24 September 2020

Ref: 20093

**Response to Council's Request for Information  
Alterations & Additions to Lennox Village Shopping Centre  
including ALDI Supermarket Extension & Car Park Modifications  
2 20 Pyramid Street Emu Plains (DA20/0457)**

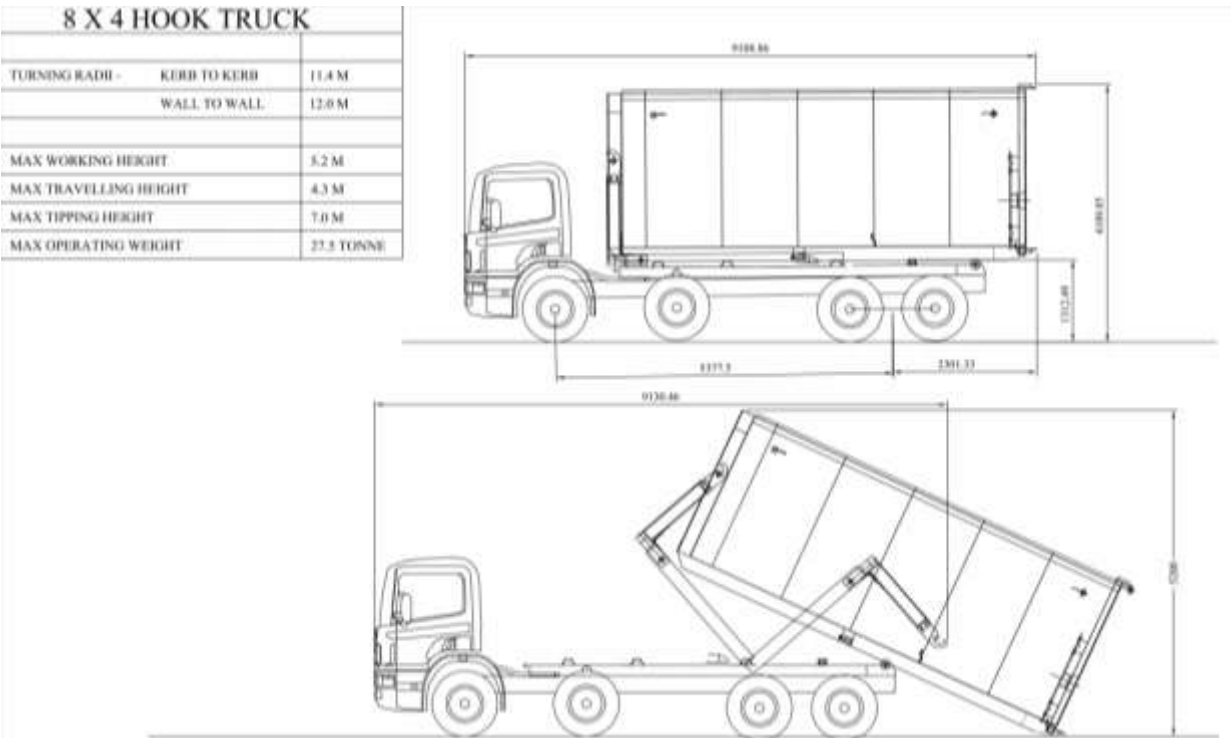
*The pre-lodgement advice detailed the conflict between the service trucks reversing into the public carpark, and conflicts with vehicles and pedestrians. It was noted the truck lane would not be supported and a reconfiguration was necessary. Apart from the proposed path along building, the traffic, pedestrian and truck reversing issues (including reversing at the pedestrian crossing in the loading access) detailed within the pre-lodgement advice have not been addressed and the application cannot be supported.*

*The submitted Traffic Report states that the existing arrangement has reversing trucks and this proposal is an improvement on the existing arrangement where trucks stop in the car park aisle to load/unload. However, any re-development must remove any truck reversing in the car park/pedestrian activity areas.*

*The application has not demonstrated compliance with Australian Standard 2890 (AS2890) regarding waste/service vehicles access, manoeuvring and reversing in traffic car parking and pedestrian activity areas. The application is also inconsistent with Penrith Development Control Plan 2014, C10 insofar as it refers to design principles to mitigate conflict between car parking, service areas and pedestrian activity.*

The reconfiguration of the servicing area to ensure no reversing is not possible due to the operating nature of the hook truck. The truck uses a hook-lift system to load the container from the ground onto the truck only from the rear, thus requiring the truck to reverse on arrival.

The following figures illustrate how a hook truck access a compactor.

Due to the operational limits of a hook truck, the truck is equipped with features to eliminate hazards or reduce risks such as reversing cameras, audible alarms, lights and mirrors.

The waste collection area has been reconfigured to be separated from the car parking area in accordance with Council's DCP Section 5.3.4.1(1). The truck will be able to enter and exit the site in a forward direction in accordance with Council's DCP Section 5.3.4.1(3).
